**Variation to the Territory Plan 368 –
City and Gateway South Northbourne Avenue Corridor**

Variation to the Territory Plan 368

City and Gateway South
Northbourne Avenue Corridor
(Barry Drive/Cooyong Street to
Antill/Mouat Street)

Figure 1: Building heights and required community use area

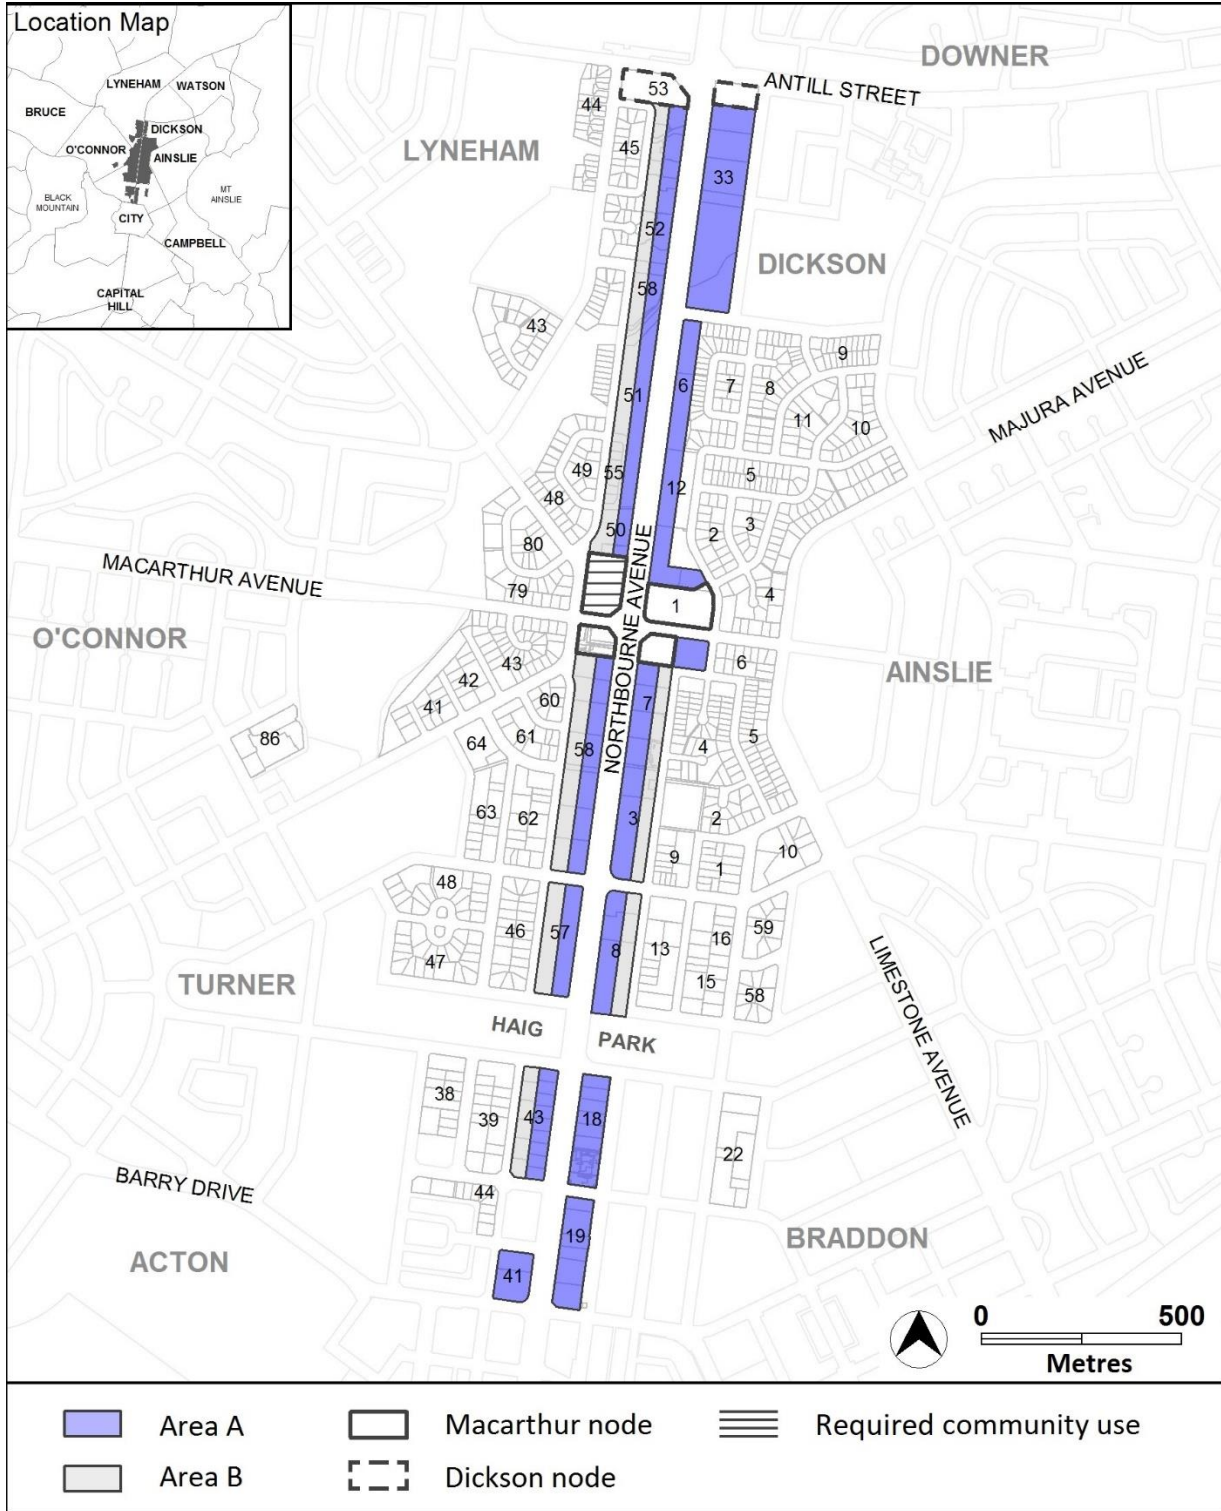
R5 of the proposed Precinct Code states that a maximum building height of buildings in Area A is 25 metres. R7 of the proposed Precinct Code states a maximum permitted building height of 32 metres at the Dickson Node. The Dickson Node however is identified as a single block on Figure 1 of the draft variation, with the block to the west of Northbourne Avenue identified as being part of 'Area A' (and therefore subject to a 25 metre height limit). Both blocks at the intersection of Northbourne Avenue with Antill/Mouat Streets should be identified as having a maximum permitted building height of 32 metres.

There are no particular rules/criteria regarding building height at the intersection of Northbourne Avenue and Wakefield/Macarthur Avenues. The combination of the proposed R5 and identifying this intersection as part of 'Area A' on Figure 1 effectively restricts buildings to 25 (or 27.5 metres). While this is not inconsistent with the Plan, the NCA expects that this is not the intended consequence of the draft variation and requests that a necessary rule/criteria be incorporated to allow buildings to the height limits permitted by the Plan.

Changes to Figure 1 may assist in clarifying permitted building heights, for example by identifying the blocks at the intersections of Northbourne Avenue with Macarthur/Wakefield Avenues and Antill/Mouat Streets in a different colour.

Figure 2: Front boundary setbacks

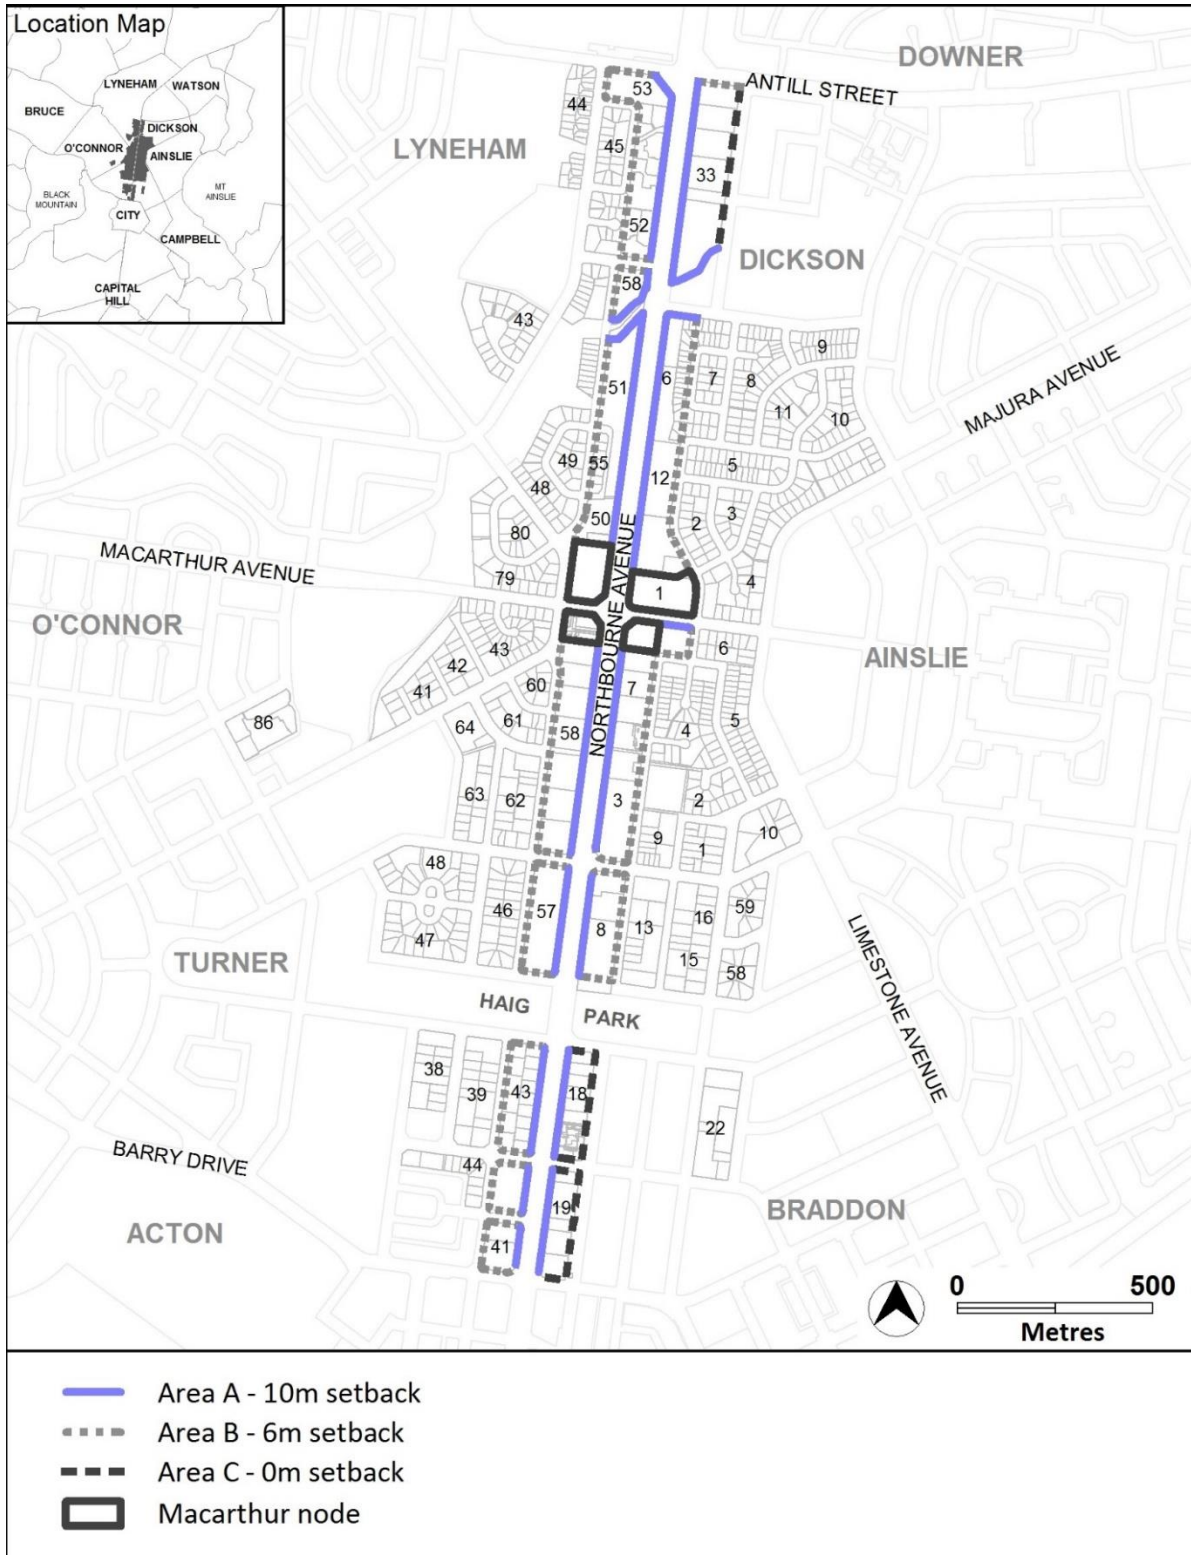
9	<p>This rule applies to blocks and parcels identified in Area A of Figure 2. Minimum front boundary setback to Northbourne Avenue is 10m. No building elements are permitted forward of the minimum front boundary setback</p>	<p>Minor encroachments by one or more of the following may be permitted forward of the building line provided the materials and design retain the visual integrity of the building line:</p> <ul style="list-style-type: none">a) awningsb) architectural details, not including:<ul style="list-style-type: none">i) basementsii) basement rampsiii) balconiesiv) service areas or facilitiesv) above ground utility infrastructurec) courtyard walls for areas of principal private open space provided the area does not encroach more than 4m into the setback area	<p>DV368 has added a mandatory provision that “Basements and balconies must not extend into the setback area adjacent to Northbourne Avenue” for a distance of 10m. We note that prior to DV368 that both basement and balconies could extend into the setback area and many developments along the Avenue have been able to provide justification against the criteria as to why these should be allowed. We would suggest that basement encroachments are permissible as long as they don’t “detract from the quality of the landscape treatment” as previously legislated and that balconies be added to the list of minor encroachments where they were listed previously. This will allow consistency along the corridor with what has been approved to date and allow design flexibility should the site constraints deem it necessary.</p>

Figure 2 has been revised to remove the Macarthur node from the setback provisions. This means that setback requirements for Macarthur node will be as per the NCP. As noted previously, unnecessary duplication between the NCP and precinct code has been removed to reduce the potential for inconsistencies between the two.

Figure 3: Additional requirements

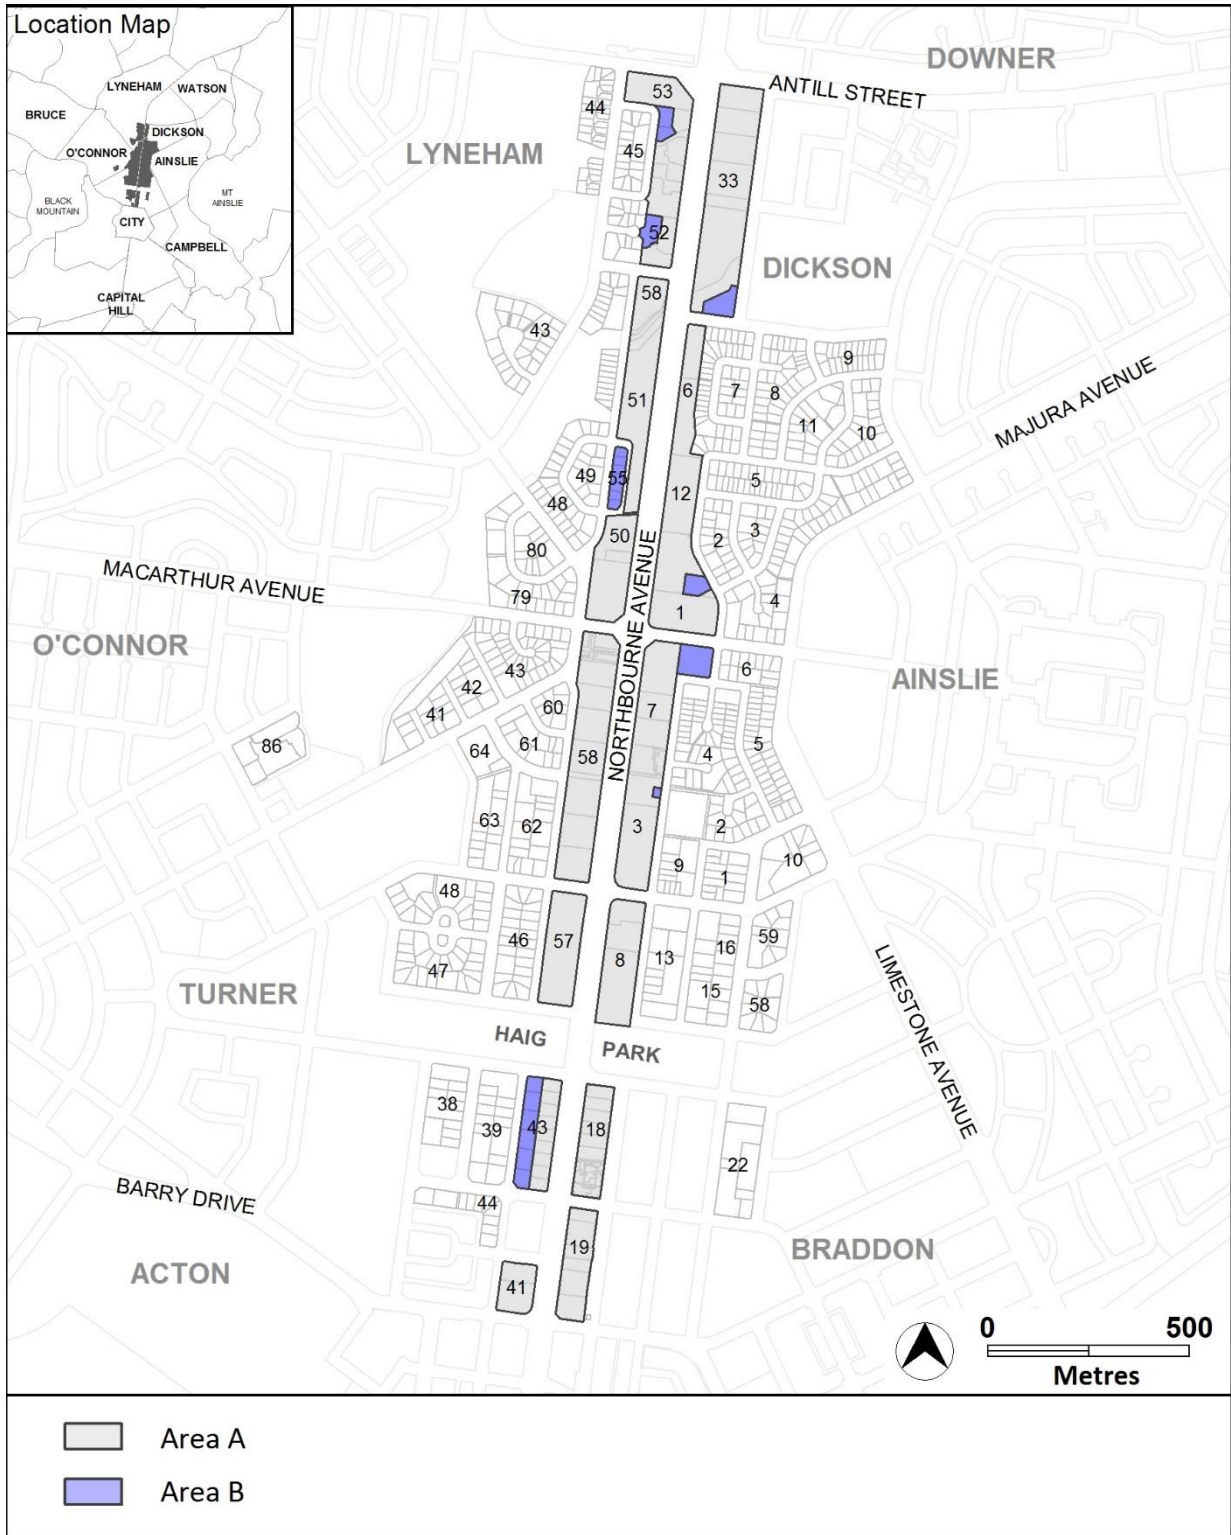
It was suggested that Rule R15 should apply to area A in figure 3 only.

One submission questioned the application of Rule R14 in that it should only apply to Area A and not to Area B on Figure 3. The same submission questioned the application of Rule R14 to commercial uses and suggested it should only apply to habitable rooms in dwellings.

Again we believe this is meant to say applies to 'Area A' in Figure 3.

Rule and Criterion R15 and C15 are intended to reflect the provisions of the National Capital Plan and as such are applicable to Area B on Figure 3.

Figure 4: Active travel links

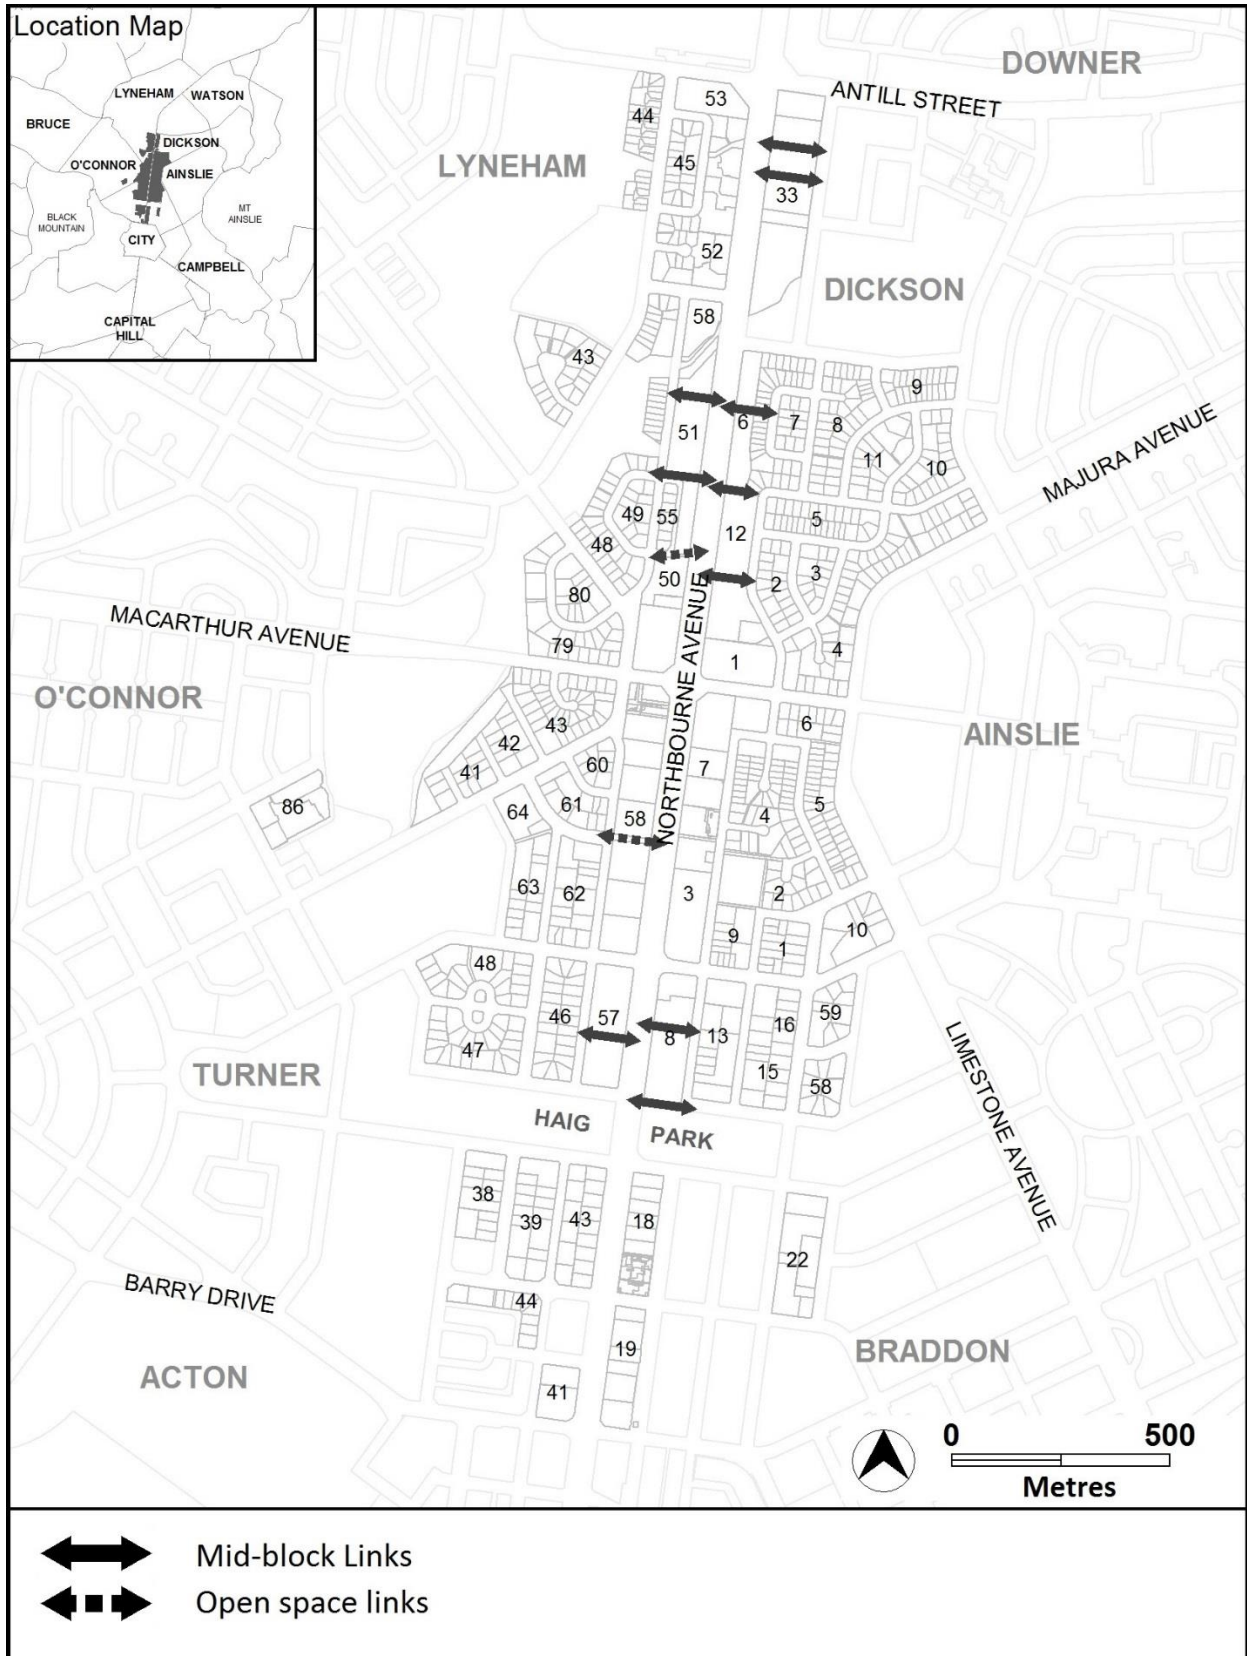
C25 contains requirements for 'open space links', with the only requirements being that unimpeded public access is provided at all times. It appears that the blocks on which 'open space links' are required, as identified in Figure 4, are all currently managed by the Transport Canberra and City Services Directorate (TCCS). Although managed by a government entity, it would be useful for additional criteria to be included regarding the intended nature of these links (for example, minimum width to promote adequate landscaping and provide a welcoming environment for users, adequate lighting, etc).

Other blocks, also managed by TCCS, perform a similar function to those identified in Figure 4 (for example, Block 3 Section 53 Lyneham and Block 4 Section 3 Braddon). Should these blocks also be identified as open space links?
